**City of Sherwood
PLANNING COMMISSION
Sherwood City Hall
22560 SW Pine Street
Sherwood, OR 97140
September 25, 2012 – 7PM**

a. *Langer Farms Phase 7* - The applicant is proposing a site plan to construct a commercial shopping center on 19.7 acres of property. The proposal includes a 189,500 square feet of commercial space which includes 145,000 square foot anchor building and six retail buildings with associated parking and landscaping.

Proposal: The applicant has requested site plan approval to construct between 190,530 and 192,532 square foot shopping center, based on the alternate options considered for proposed pads A and C, on approximately 19.82 acres of a 55.09 acre parcel of land. The request also includes a conditional use permit to allow outside storage and sales, and a separate request for a design modification to the right-of-way requirements for the extension of SW Century Blvd. to allow the sidewalk to be placed curb tight and street trees to be planted within tree wells. The parent parcel (55.09 acres) recently received preliminary subdivision (SUB 12-02) approval to divide the land into five individual lots and two tracts for future development consistent with th

TRASH ENCLOSURE ELEVATIONS #4
3/32" = 1'-0"

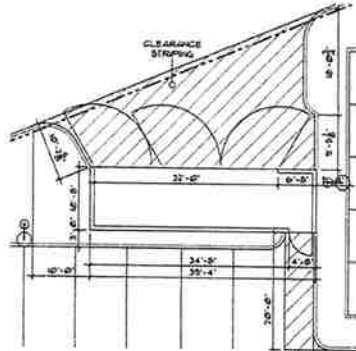
Pride Disposal Co.: Kristin Leichner of Pride Disposal, provided staff with comments that indicates that Pride disposal has some concerns with two of the six proposed enclosure locations. She added that it would be possible to redesign them in order to be serviceable. Ms. Leichner's comments are attached to this report as Exhibit H.

Good morning Kristin, attached is a revised Sheet A1.2 with dimensions on the trash enclosures. Also, I made up a second sheet, which shows both an expanded area at the 3-bay enclosure, and an enlarged plan at the anchor's disposal area.

Exhibit 1. Northbound Add Lane on Highway 99W (Image Source: Google Earth)

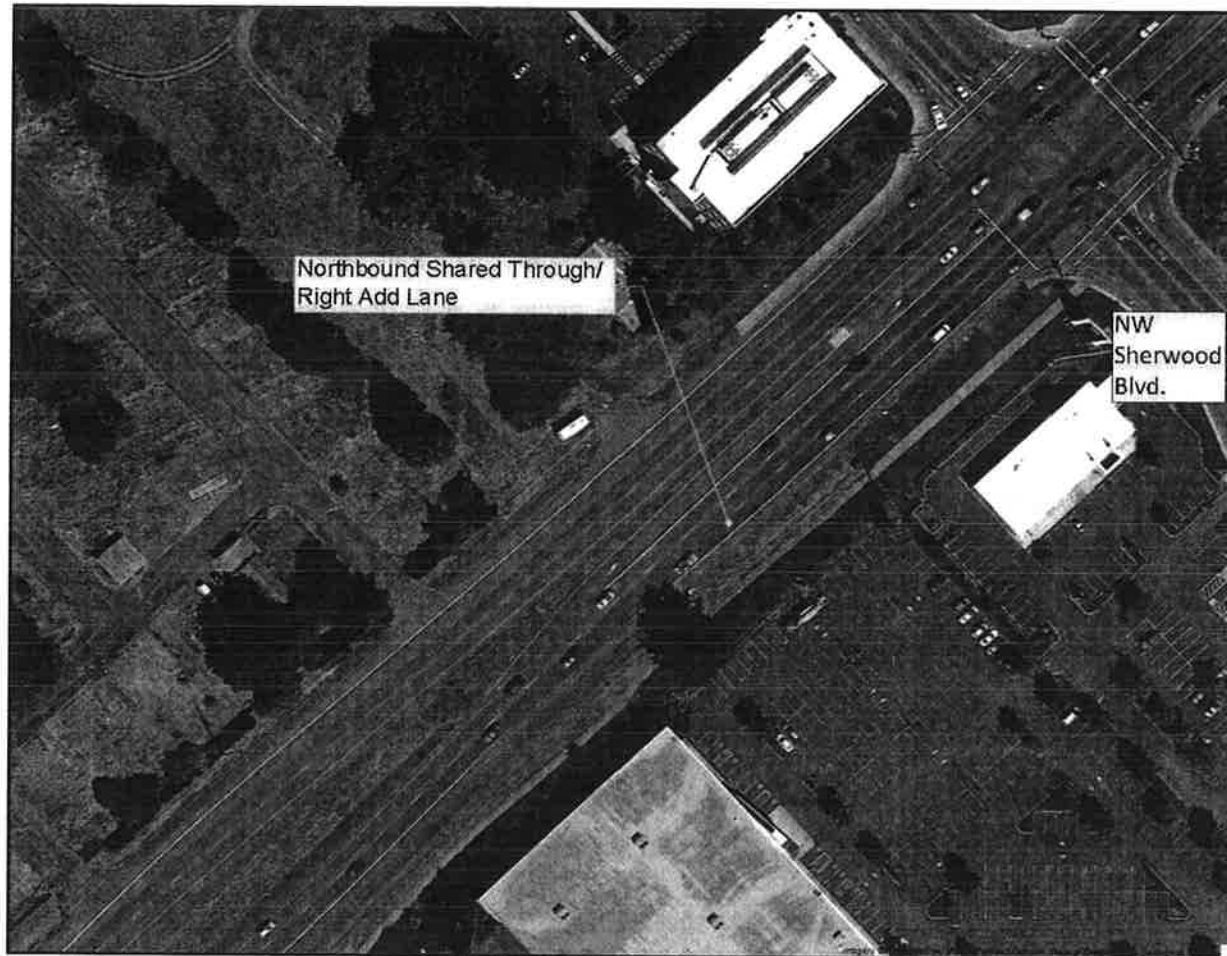
- 1. 99W/SW Sherwood Blvd Intersection: The applicant shall lengthen the storage distance on the northbound right turn lane to 625 ft with the associated deceleration distance.*

While ODOT's letter recommends extending the Highway 99W northbound right-turn lane storage distance to 625 feet, there is not a dedicate right-turn lane today. As shown in Exhibit 1 below, there is an add lane south of SW Sherwood Boulevard, where the Highway 99W northbound lanes widen from a northbound through lane and shared through/right lane to two northbound through lanes and a shared through/right lane. As an add lane, through traffic tends to use the shared lane when storage is available but only up to the available storage – through vehicles otherwise remain in the two other through lanes.

We separately analyzed intersection operations and queuing at the 99W/SW Sherwood Boulevard-SW Edy Road intersection assuming two northbound through lanes and a dedicated right-turn lane. The results of the analysis indicate that a *separate* northbound right-turn lane would operate with a 95th percentile queue of approximately 250 feet; 50 feet short of the 300 feet of available storage. Based on this analysis, there is not a need for additional queue storage if the lane is striped as a northbound right-turn only lane as suggested by the ODOT letter.
